STAFF REPORT

APPLICATIONS PCA/FDPA 2006-SU-007

APPLICANT: Timber Ridge at EDS, LLC

PROFFERED CONDITIONS AMENDMENT /
 CONCEPTUAL / FINAL DEVELOPMENT PLAN AMENDMENT
TIMBER RIDGE AT EDS

Graphic 1: The Original Rezoning Site by Blocks

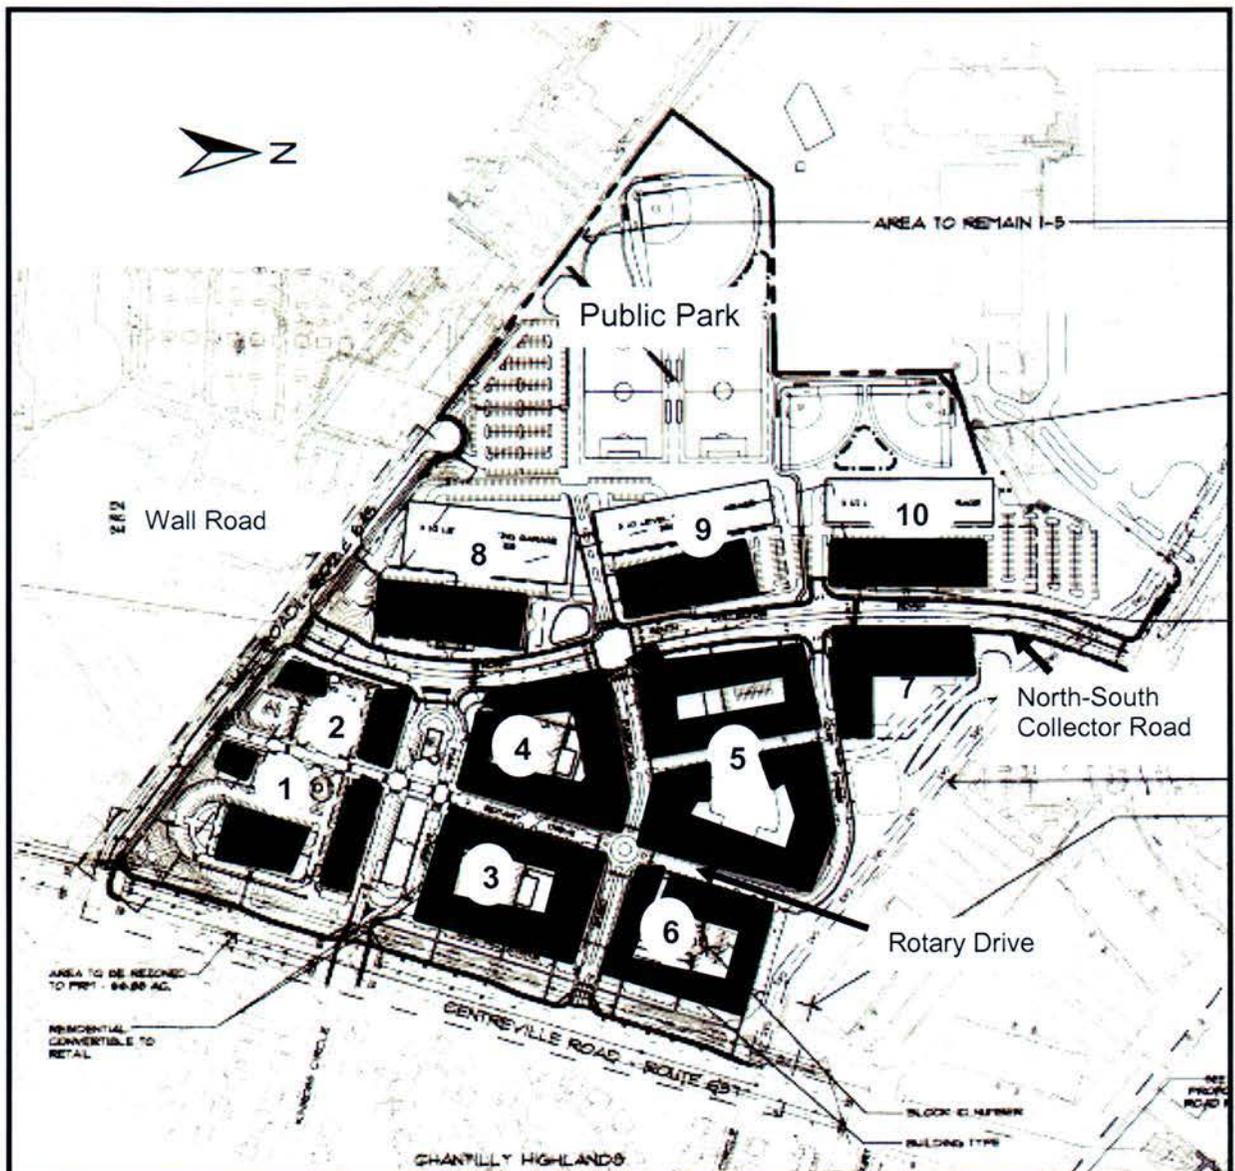
Although not part of the original rezoning application area, the development also provided 17 acres of parkland in an area abutting the western boundary of the property and committed to the construction of five athletic fields on that site, which would replace the fields currently being used by the Centreville Youth Association. The athletic complex consisted of two 60-foot and one 90-foot sodded baseball diamonds; and two approximately 195 x 360-foot rectangular fields topped with synthetic turf for soccer, field hockey or lacrosse, all of which would be constructed to Park Authority specifications.

Graphic 2: Proposed Changes

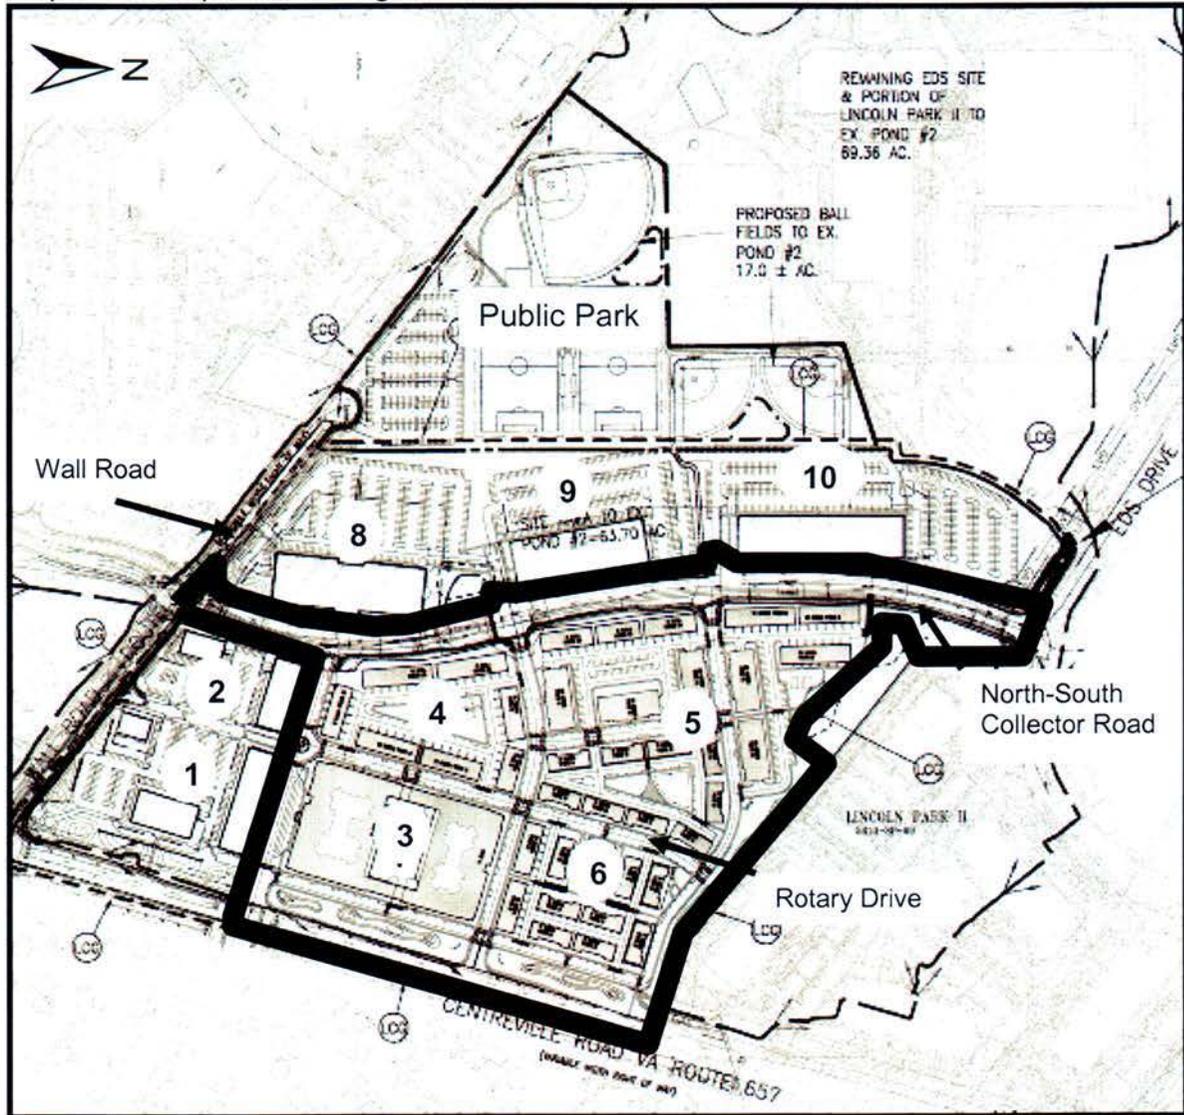
increasing the building height from 62 feet to 70 feet; realigning some of the internal streets; areas of open space; and the location of recreational amenities; and redistributing the parking associated with the residential development. Graphic 2 below highlights the proposed changes.
